UNITED STATES PATENT AND TRADEMARK OFFICE

APPLICATION NO.	FILING DATE	FIRST NAMED INVENTOR	ATTORNEY DOCKET NO.	CONFIRMATION NO.
10/762,261	01/23/2004	Chun Fu Wu	BHT-3117-181	5531

Office Action Summary

DETAILED ACTION

Figure 1. Sutt Jr. US-5,865,585

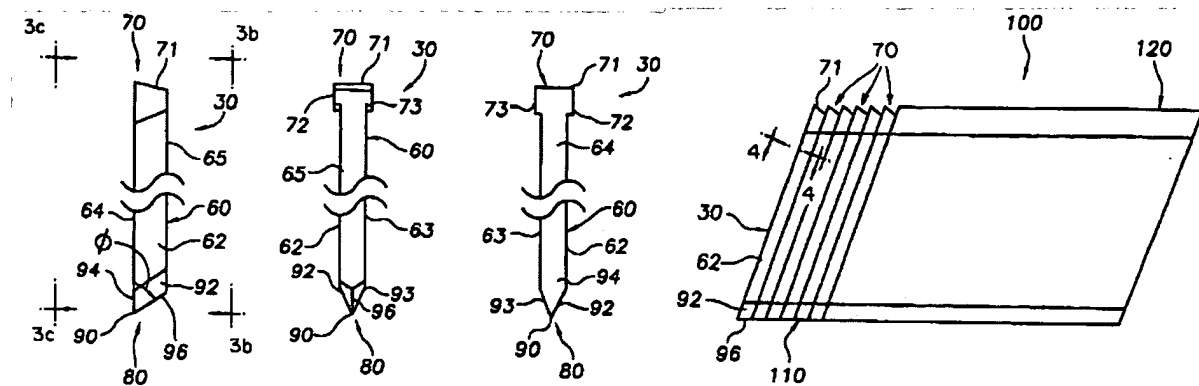
Sutt Jr. teaches:

"nail heads (70) of a nail row (100) comprising a plurality of T-shaped nails (30) connected together alongside, each said nail formed with a nail head (70) and a nail shank (60), the distance between the front (72) and the rear (73) side of said nail head (70) being a little larger than the thickness of said nail shank (60), said nail head having its topside (71) formed with a flat striking surface, said flat striking surface having its left (64) and right (65) side respectively extending straight downward to the lowermost end of said nail shank (96) and forming a connecting portion (64 & 65), said nails respectively having said connecting portions coated with adhesives (Col 7 Line 44, Col 3 Line 22) and connected together to make up said nail row (100)"

as described in the instant claim 1. See Figure 1 below.

Sutt Jr. does not mention symmetrical oblique insert members respectively formed under the protruding portion of the front and rear side of said nail head.

Figure 2. Leistner US-5,482,419

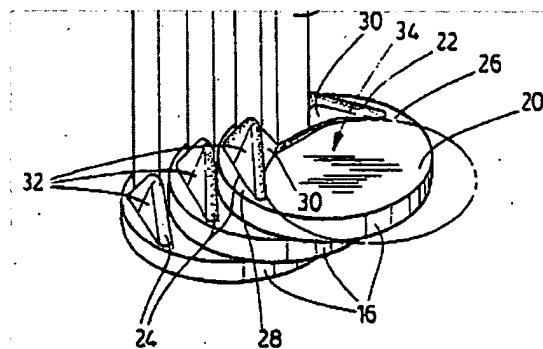
Leistner teaches:

“symmetrical oblique insert members (24, 22) respectively formed under the protruding portion of the front (near 28) and the rear (near 26) side of said nail head, each said oblique insert member composed of a horizontal plane (28, 26) and an inclined plane (30) connected with each other, said horizontal plane and said inclined plane having their lengths preset in proper proportion, said inclined plane (30) of oblique insert member (24, 22) forming an acute angle (Col 4 Line 17) to the vertical side of said nail head to make up a sharp nailing portion: and, said horizontal plane (28, 26) of said oblique insert member parallel to said flat striking portion (Phantom Line), a preset height formed between said horizontal plane and said flat striking surface, said preset height forming a thickness strong enough to resist striking (Col 1 Lines 19 and 21), said sharp nailing portion of said oblique insert member enabling said nail head of said nail to be smoothly nailed in a workpiece, said horizontal plane and said inclined plane combined with said workpiece by mutual engagement of different levels, enhancing their combination strength (Col 4 Lines 26-29)”

as described in the instant claim 1. See Figure 2 below.

At the time of invention, it would have been obvious to one ordinarily skilled in the art, to modify the nail heads in the nail row taught by Sutt Jr., to comprise the oblique insert members taught by Leistner, in order to enhance the combined strength of those members with a workpiece, and to allow the plane under the nail head to help strengthen the combination of workpieces as disclosed in the instant specification (Page 2 Lines 11-13).

Figure 3. Leistner US-5,482,419

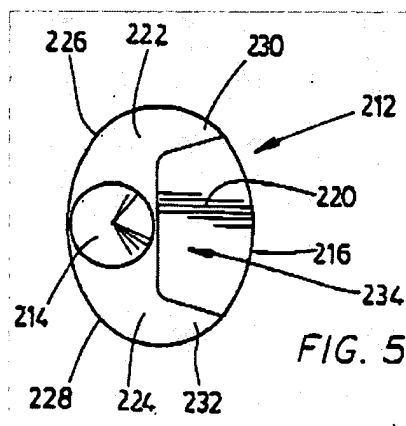
[6] As for claim 2, Leistner teaches (in Col 4 Lines 57-61) that the oblique insert members (24) “are provided on the lower surfaces 226, 228 respectively...[and] extend across and may cover the entire surfaces 226, 228 around the surface 220.” See Figure 3 below.

Therefore, Leistner discloses a variety of configurations with regard to the horizontal (28, 26) and oblique (30) plane lengths of the oblique insert members (24), but does not disclose expressly the proportion in length of the horizontal (28 & 26) and inclined (30) planes as being two to one.

At the time of invention, it would have been an obvious matter of design choice to a person of ordinary skill in the art to modify the oblique members taught by Leistner so that both horizontal (28 & 26) and inclined (30) planes of said members would have a proportion in length

of two to one, because the applicant has not disclosed that a proportion in length of two to one solves any stated problem, is used for a particular purpose, or provides any particular advantage. Further, Leistner would have been expected by those of ordinary skill in the art to perform equally well with either a proportion in length of two to one, or any other proportion thereof, because he discloses the possibility of different oblique member sizes as discussed above.

Figure 4. Rogers US-161,280

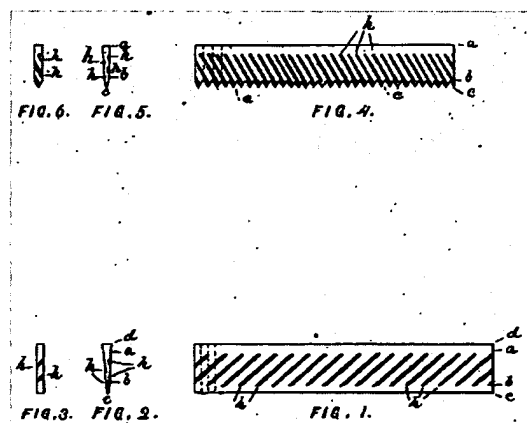
Rogers shows a strip of nails with a plurality of oblique recessed lines on both the front and rear sides of each nail shank obliquely connected with one another. See Figure 4 below.

At the time of invention, it would have been obvious to one ordinarily skilled in the art to modify the strip of nails taught by Sutt Jr. v Leistner to include a plurality of oblique recessed lines on both the front and rear sides of the nail shank as taught by Rogers, for purposes of better securing two workpieces together.
